THE ALERT
By Michael Latorre

AIR TRAILS PICTORIAL
AMA PLAN #20013
POND PLAN #1A5

DECEMBER, 1942

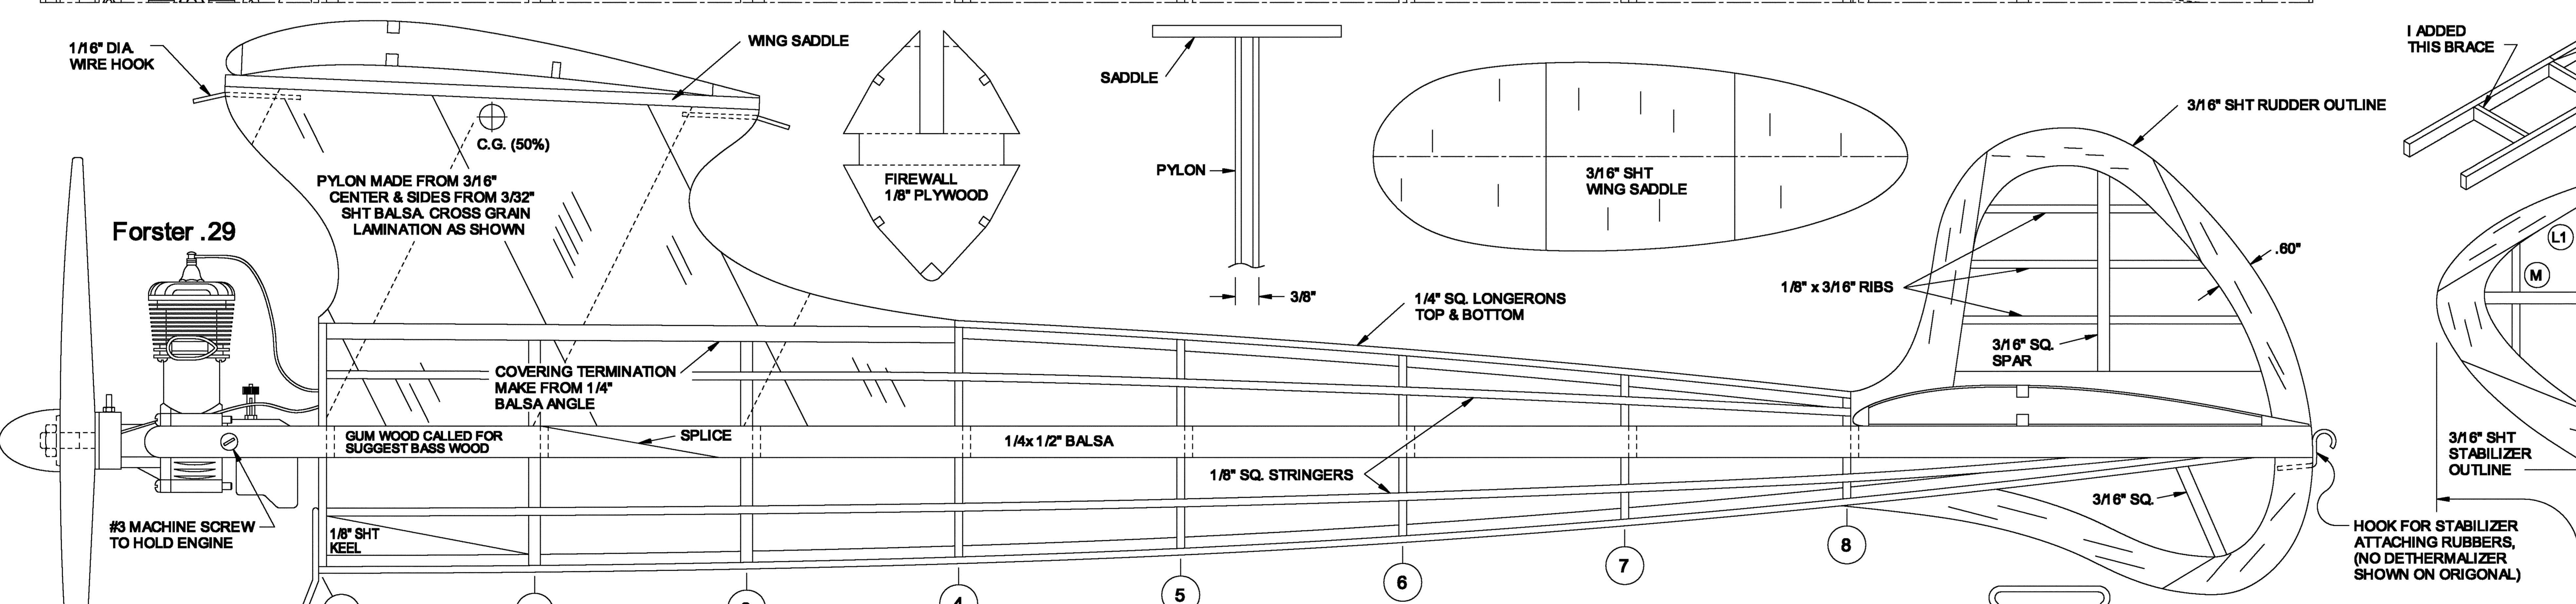
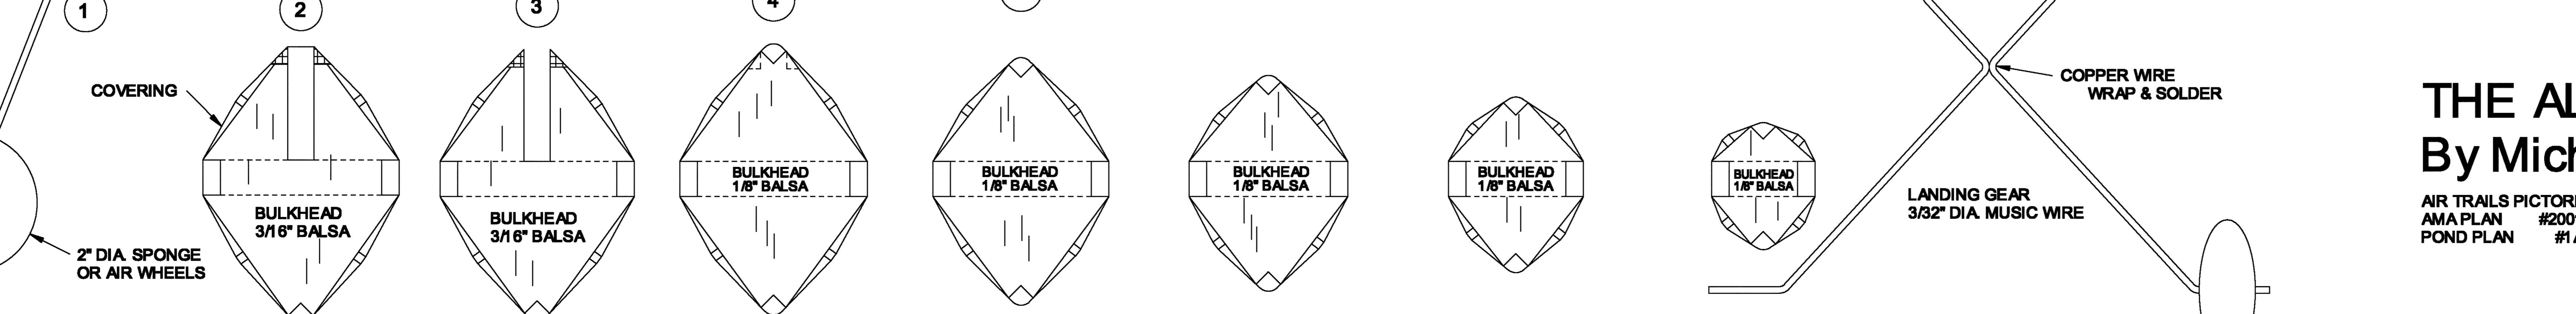
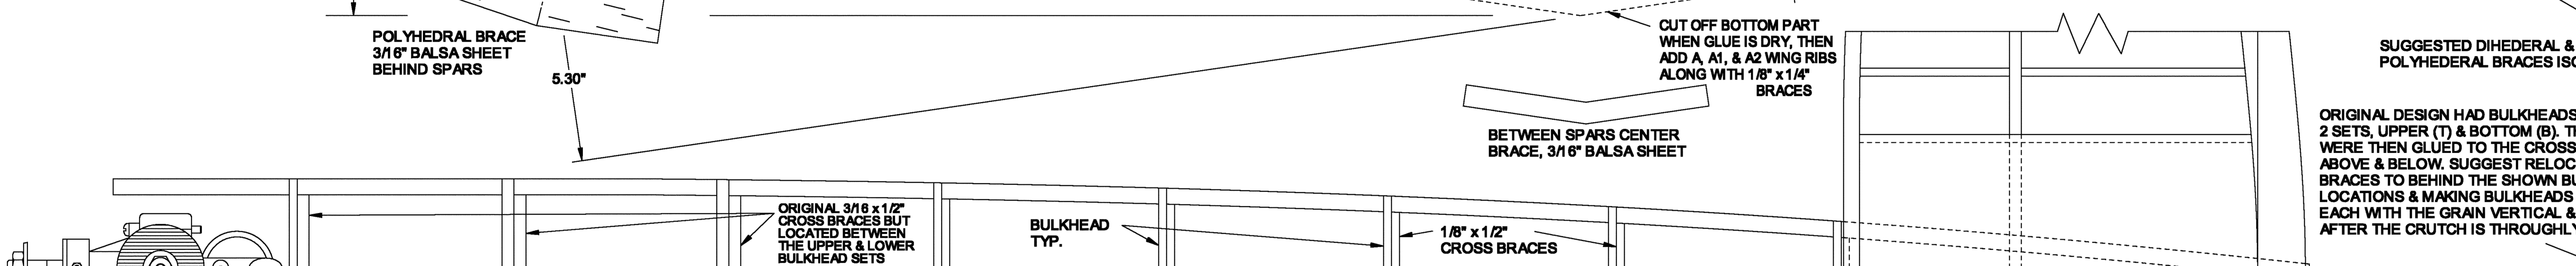
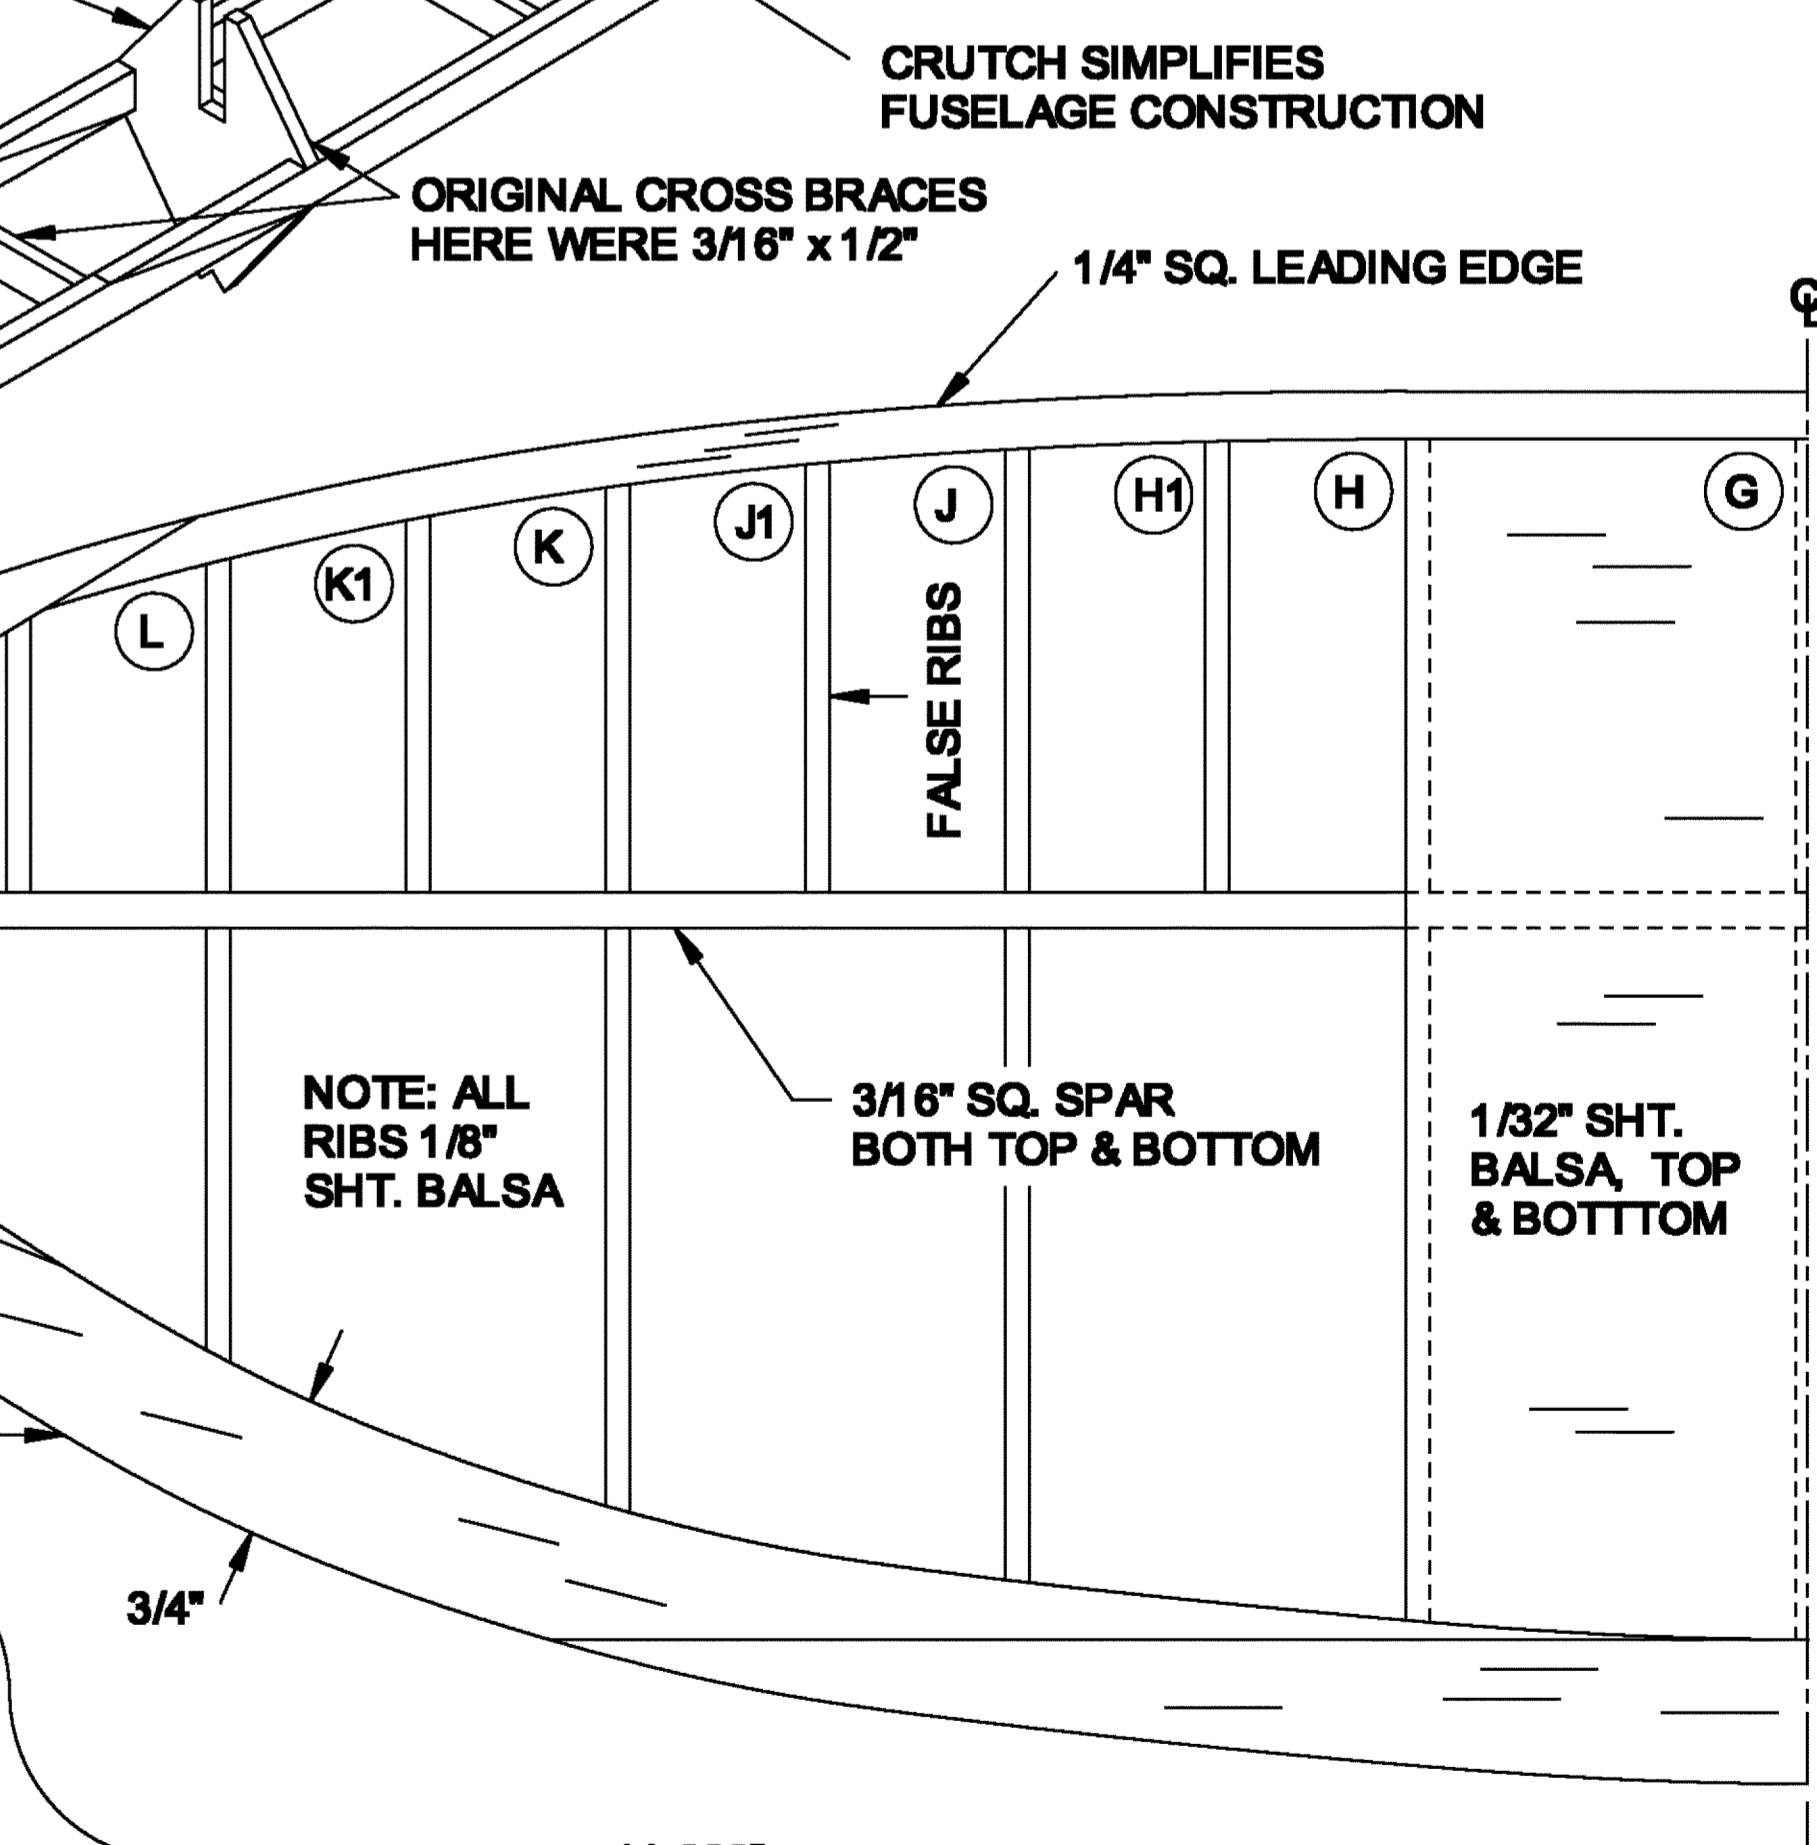
ORIGINAL DESIGN HAD BULKHEADS MADE IN 2 SETS, UPPER (T) & BOTTOM (B). THESE SETS WERE THEN GLUED TO THE CROSS BRACES ABOVE & BELOW. SUGGEST RELOCATING THE BRACES TO BEHIND THE SHOWN BULKHEAD LOCATIONS & MAKING BULKHEADS IN ONE PIECE EACH WITH THE GRAIN VERTICAL & ADDING THEM AFTER THE CRUTCH IS THOROUGHLY DRY.
